# Wisconsin Department of Transportation

### NOTICE TO ALL CONTRACTORS:

**Proposal #14: 1130-32-71, WISC 2018 011**  
**Green Bay - Oconto**  
**Lineville Road – Norfield Road**  
**USH 41**  
**Brown County**

This is Addendum No. 02, which provides for the following:

**Addendum No. 02**  
**ID 1130-32-71**  
**Revised Sheet 12**  
**December 7, 2017**

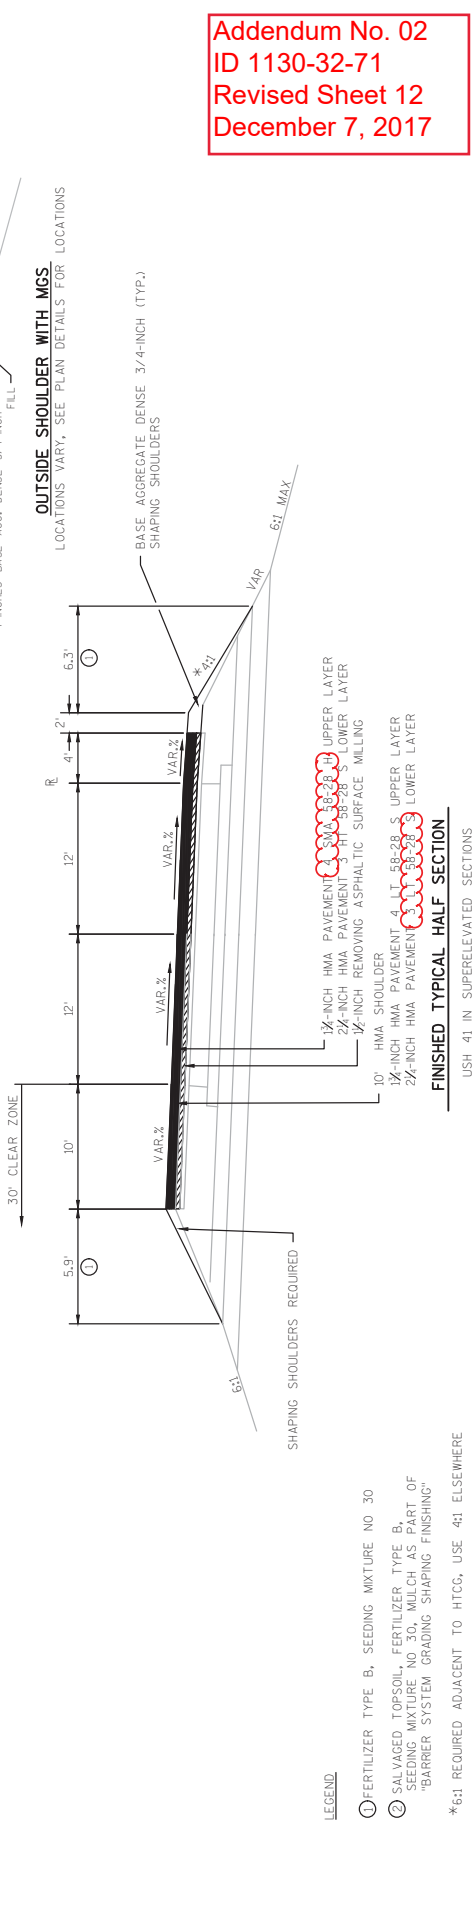
<b>1130-32-71 &amp; 1150-54-71 Plan sheets Revised Plan Sheets</b>	
Sheet #	Plan Sheet Title (brief description of changes to sheet)
12	(Finished Typical Sections) Changed mix types on mainline surface and shoulder bottom layer
245	(Miscellaneous Quantities) Revised 3LT 58-28S, 4LT 58- 28S, and Reheating Long joints quantity, Replaced HMA pavement 4 HT 58-28H with 4 SMA 58-28H, removed incentive tonnage columns
507	(Cross Section, Quantities, and Notes) Changed superstructure quantity for bid item 505.0600.
516	(Superstructure Reinforcing Plan) Changed spacing of S920 bars. Added S580 and S581 bars.
517	(Superstructure Section) Changed spacing of longitudinal bars.
519	(Superstructure Details-2) Changed quantity of S515 and S516 bars. Added S580 and S581 bars.
523	(Cross Section, Quantities, and Notes) Changed superstructure quantity for bid item 505.0600.
532	(Superstructure Reinforcing Plan) Changed spacing of S920 bars. Added S580 and S581 bars.

Addendum No. 02  
ID 1130-32-71  
Revised Sheet 533  
December 7, 2017

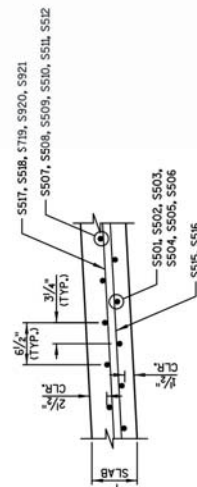
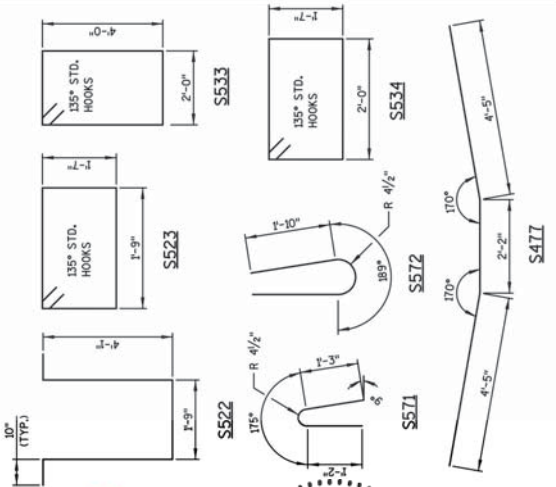
533	(Superstructure Section) Changed spacing of longitudinal bars.
535	(Superstructure Details-2) Changed quantity of S515 and S516 bars. Added S580 and S581 bars.
